CITY OF BLOOMINGTON
BOARD OF ZONING APPEALS
June 18, 2020 at 5:30 p.m.

BLOOMINGTON BOARD OF ZONING APPEALS
STAFF REPORT
LOCATION: 621 N. Lincoln St.

**BLOOMINGTON BOARD OF ZONING APPEALS
STAFF REPORT
Location: 914 W. 1st Street**

**BLOOMINGTON BOARD OF ZONING APPEALS
STAFF REPORT
Location: 1016 W Kirkwood Avenue**

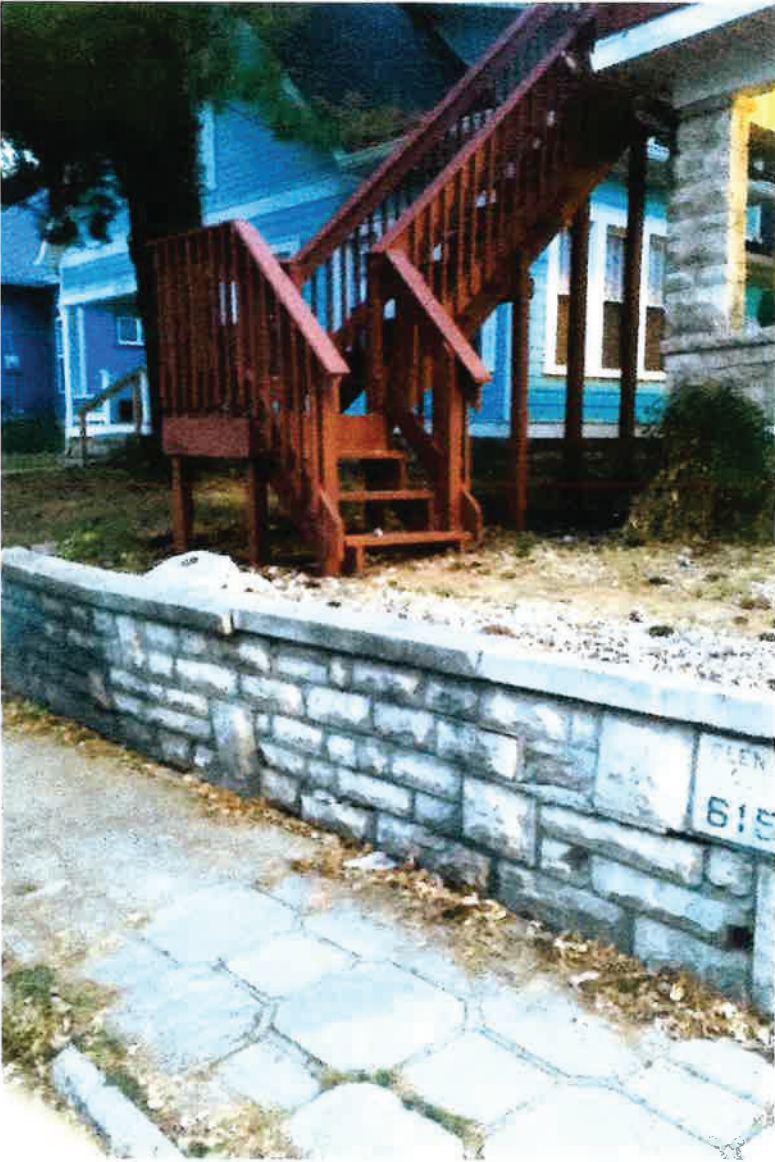
The entry doorway to the residence is elevated. The house had a set of four concrete steps leading to the front door. There was no landing at the top of the steps. Guests coming to the home would be required to stand on the top step waiting for the door to be opened.

I decided to add new steps covering over the existing concrete steps and a small deck, which also serves as a landing for persons coming to the front door, as well as serves as a small front porch. I called to check on any building permit requirement. I was told no permit required for the stairs and deck. I was not aware of any other permit or requirement. I looked around the neighborhood and saw other stairs and decks similar to what I intended to construct. I worked within the area on the lot less than areas on other lots where new stairs and decks has been added. I assumed that what I planned was permitted since it was less intrusive than I see for existing, recent construction on other lots in the neighborhood. I did not think there was any problem with my improvements to the property.

In addition to the encroachment into the setback area, I have been advised that the property does not meet the required minimum 40% maximum impervious surface requirement. The deck and steps that I added to the property did not increase the amount of impervious surface or at most a negligible amount. While the deck and steps are wood structures, it is not solid wood construction. It is planks, meaning there are gaps and spaces between all of the planks allowing rain water to run off the steps on the deck along the edges, but also between the planks and the boards that comprise the steps and the flooring of the deck. The deck is elevated and the ground beneath the deck is essentially undisturbed and remains the same surface as before with the exception of the support posts for the stairs and deck.

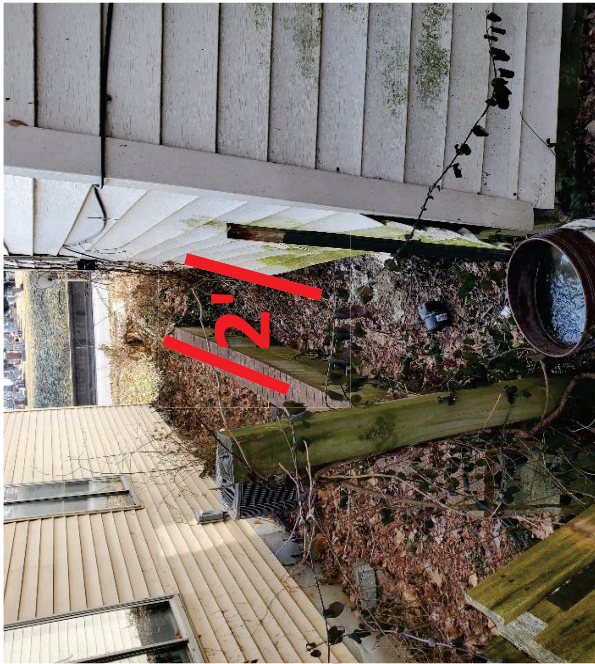
We would like to request a variance on the side building setback to 3 feet. The property is a narrow lot, 40' x 140'. Allowing a 3' set back, would allow the home foundation of 34' wide. As you can see on the documents provided, the present property has a set back of two feet and the existing home is 36'. Also, other homes on West Kirkwood are comparable to our request.

We would like to request a setback to the front of the house of 7'. This is the set of the existing house as well as other homes on West Kirkwood. 1000 West Kirkwood has a setback of 3'. Please see attached document.

We would like to request the setback of the detached garage in the rear of the property to be 10'. The attached document shows setbacks on other properties of 2' (1012 West Kirkwood), 8' (1008 West Kirkwood) and 10' (1025 West 6th St)

We would also like to request the detached garage to be 720 sq ft. or 140 sq ft additional over maximum 580 sq ft. Attached document shows the proposed garage. This additional 6' x 24' would allow for a small work area for my hobby of refinishing wood furniture.

Current House at 1016 West Kirkwood

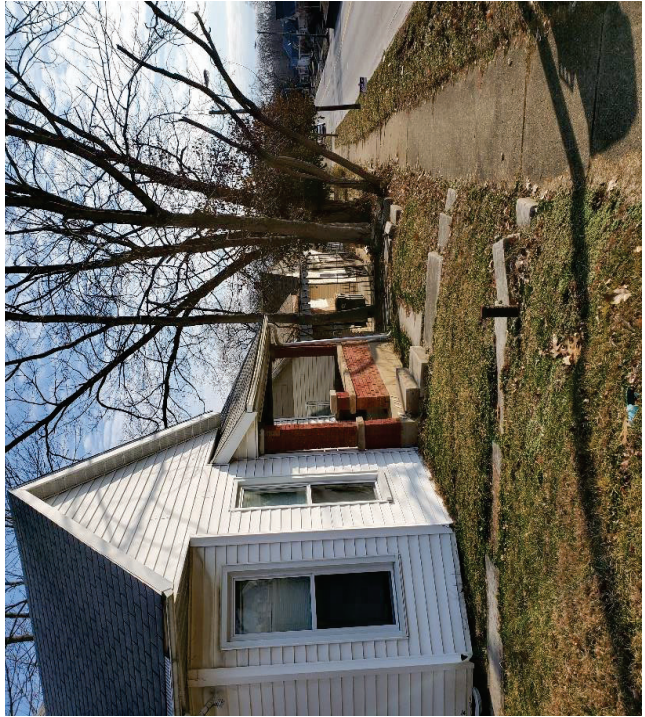
Foundation 2' from East Property Line

Foundation 2' from West Property Line
